BID ADDENDUM NO. 1

PROJECT NAME: PORT CHESTER HIGH SCHOOL ADDITIONS, ALTERATIONS
AND ATHLETIC FIELD

F&D PROJECT #: PCHS # 17295.03

DATE: February 14, 2019

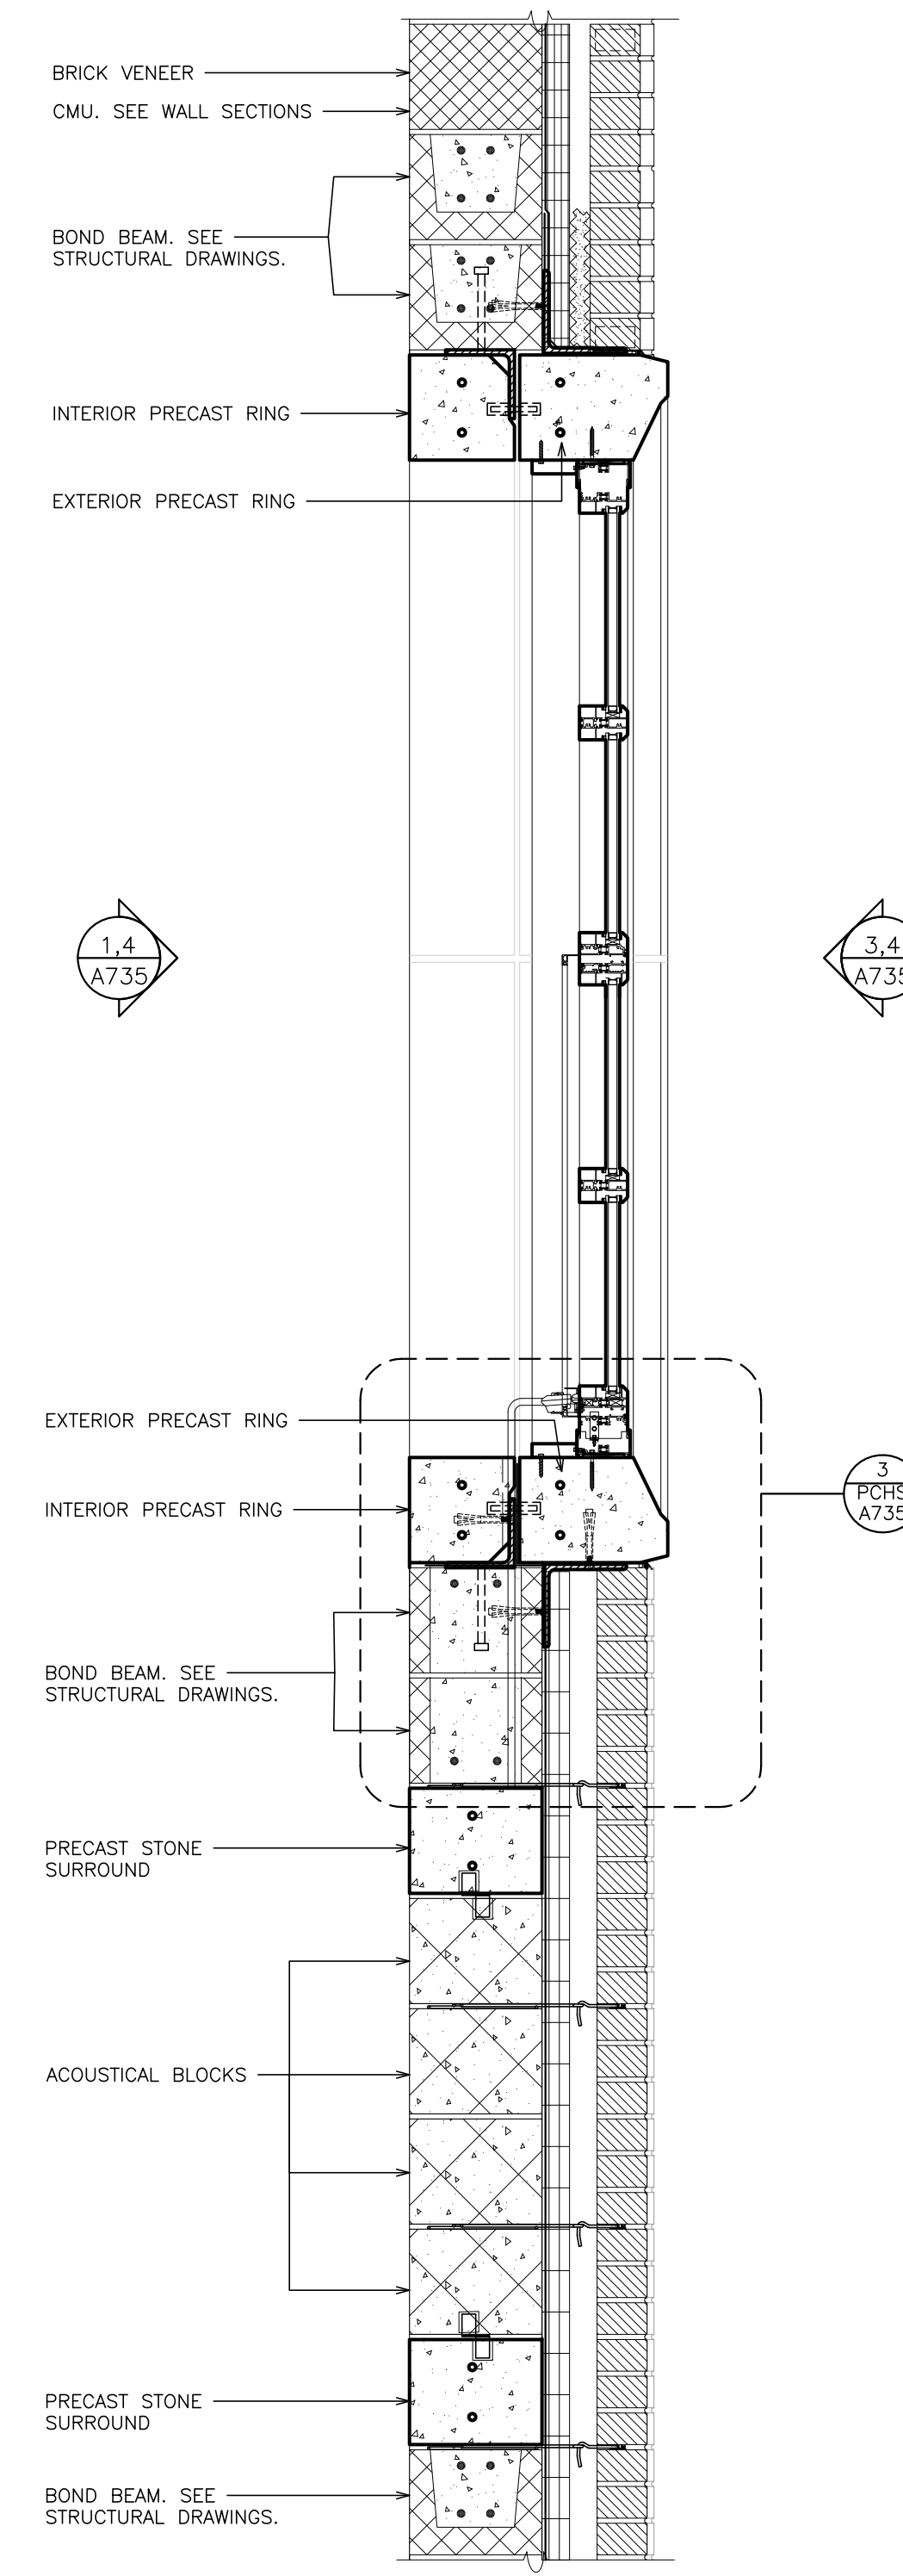
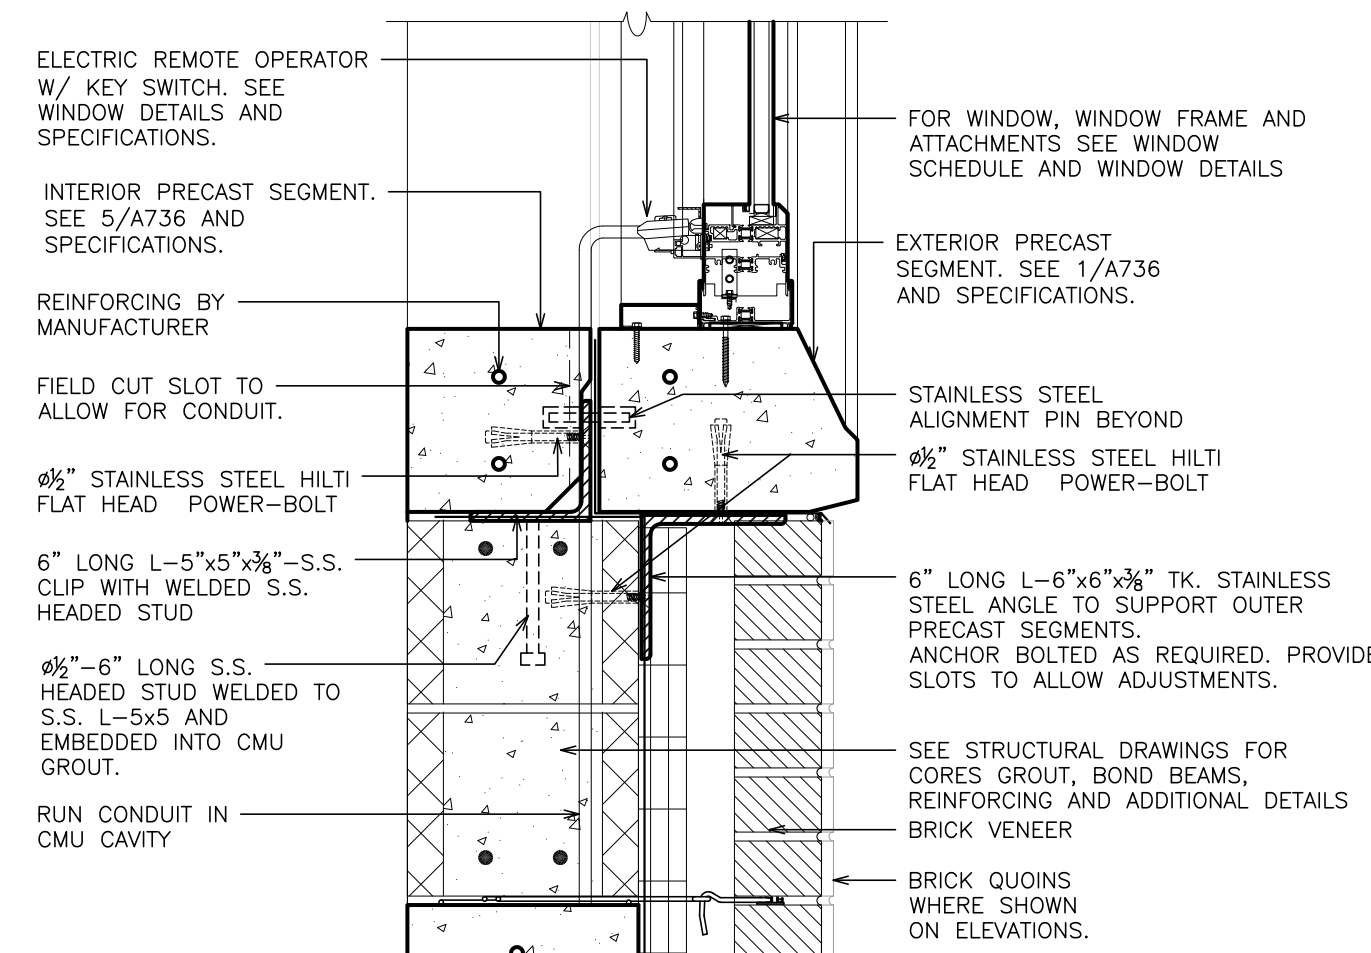
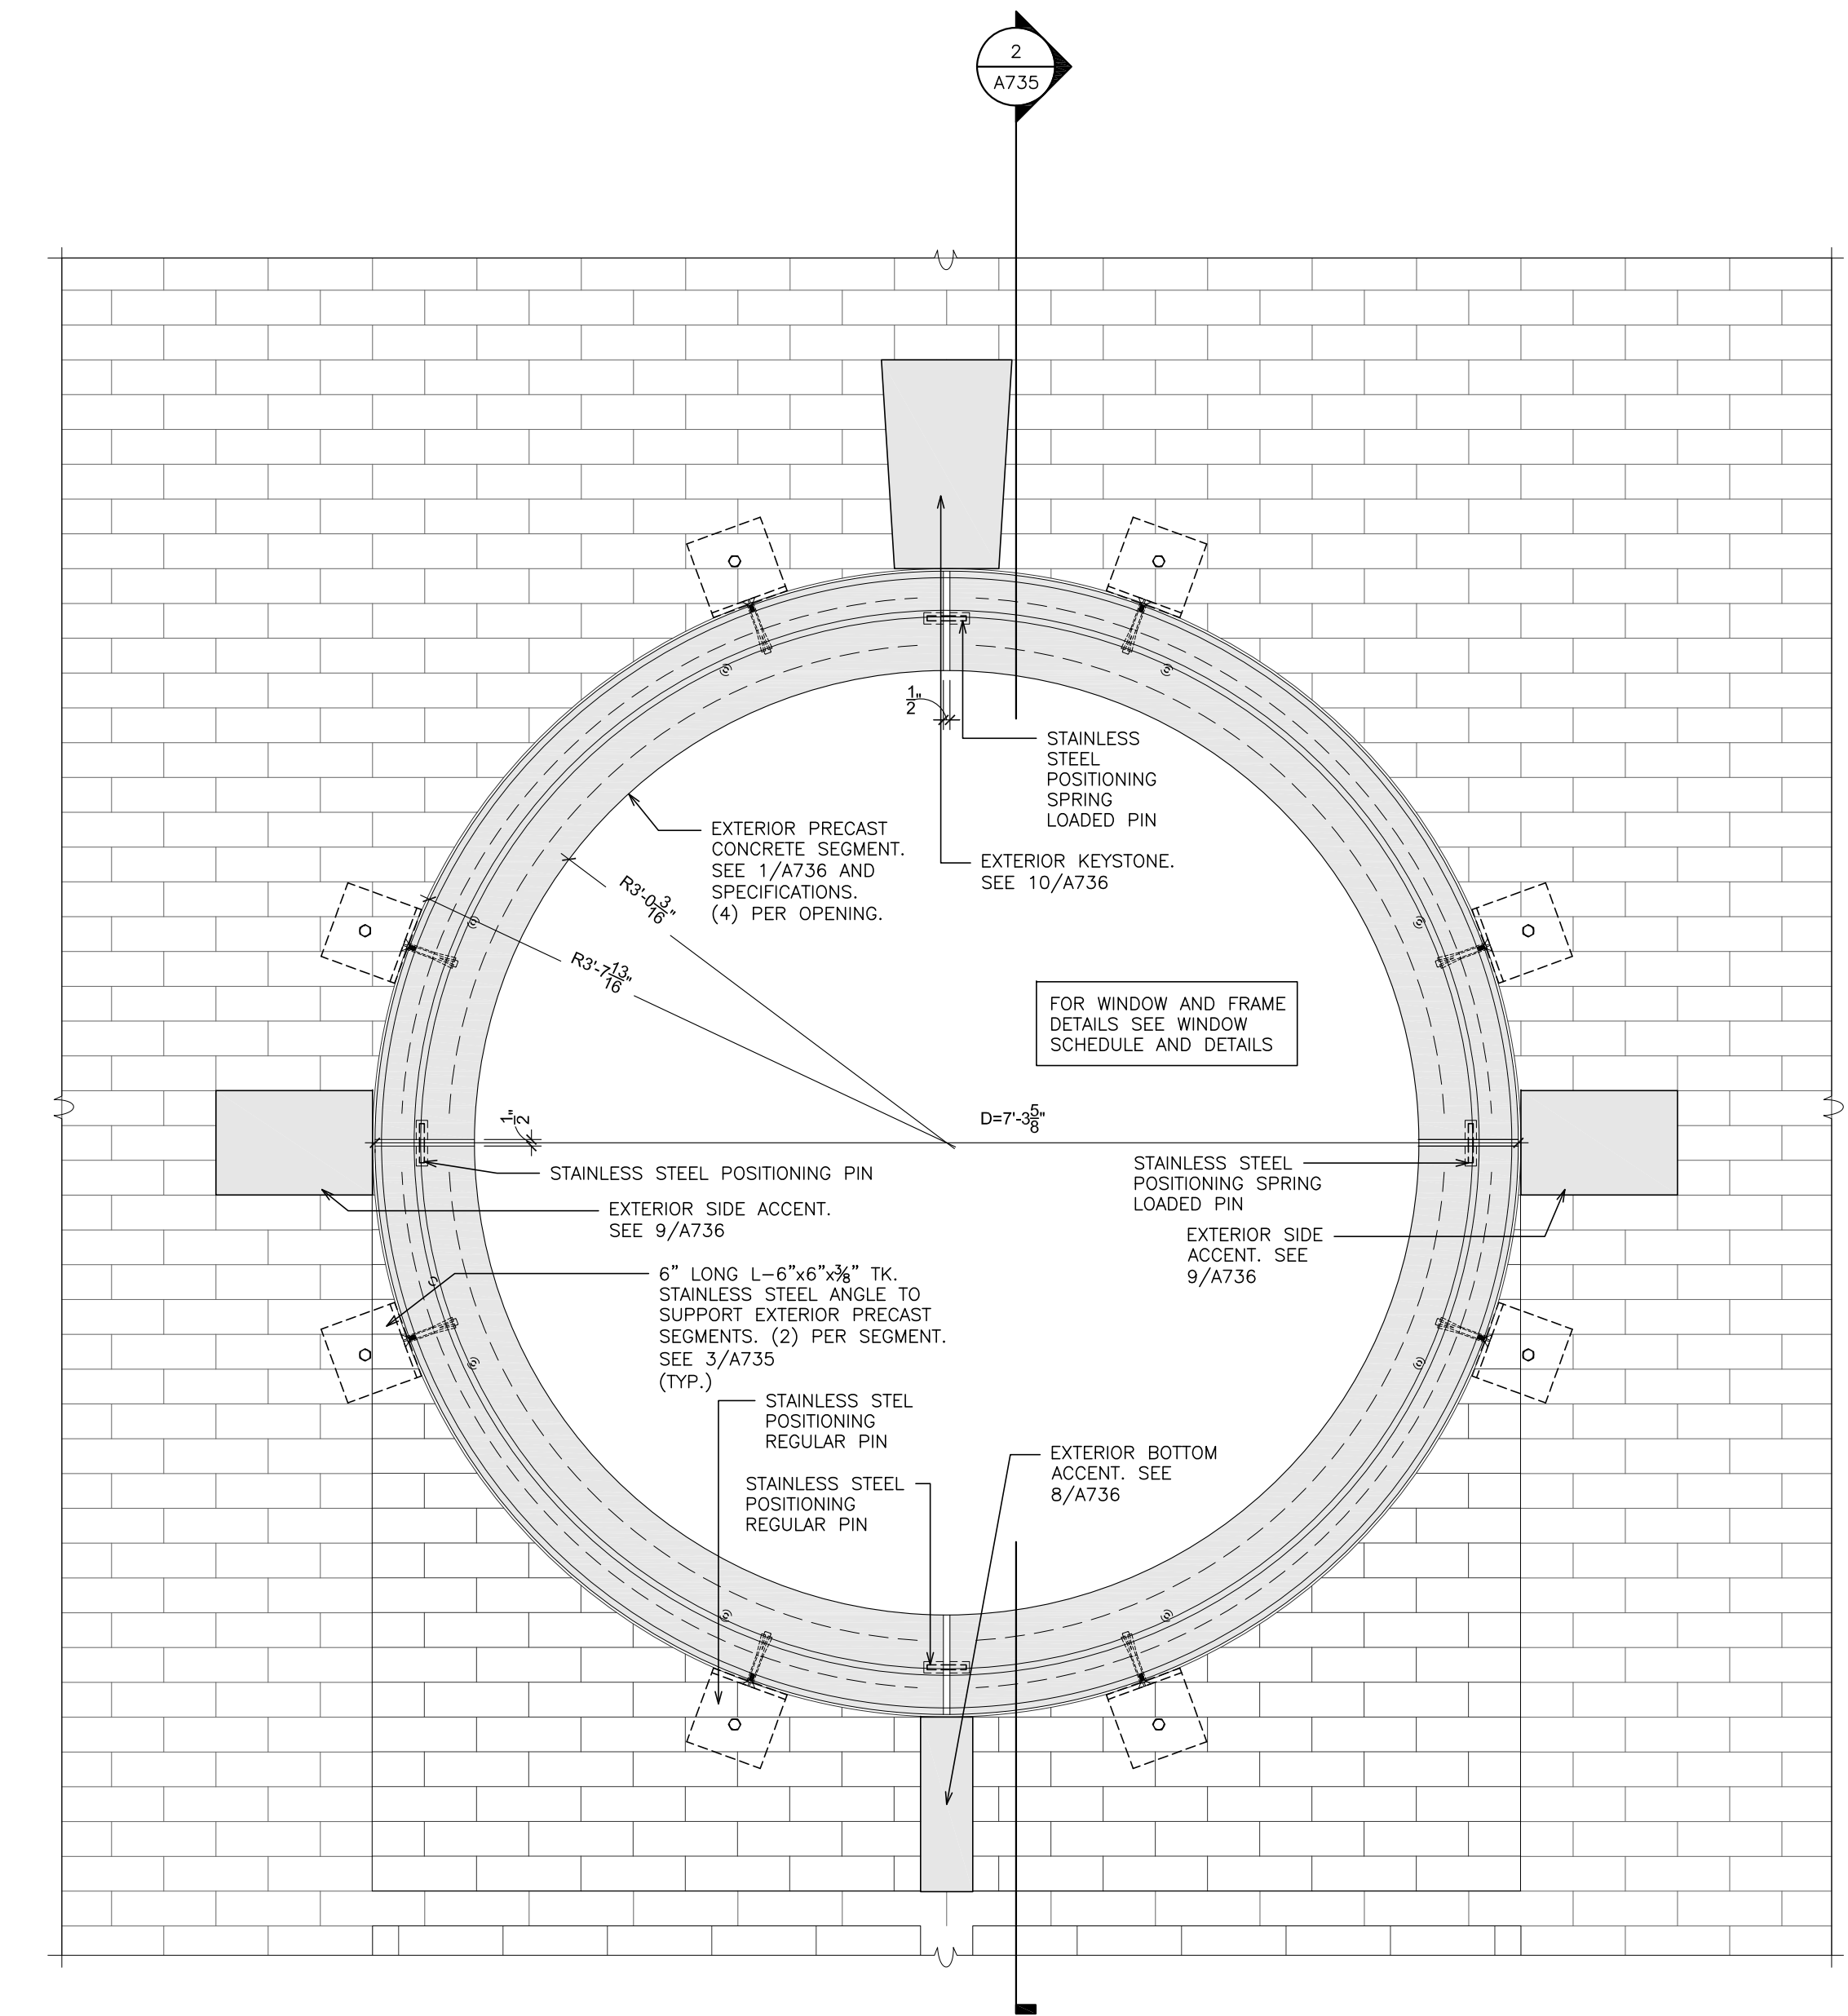
See Drawing A735 for precast stone detailing at round gymnasium windows. Note anchors and modified keystone locations/dimensions. (Drawing A735 issued as part of this addendum.)
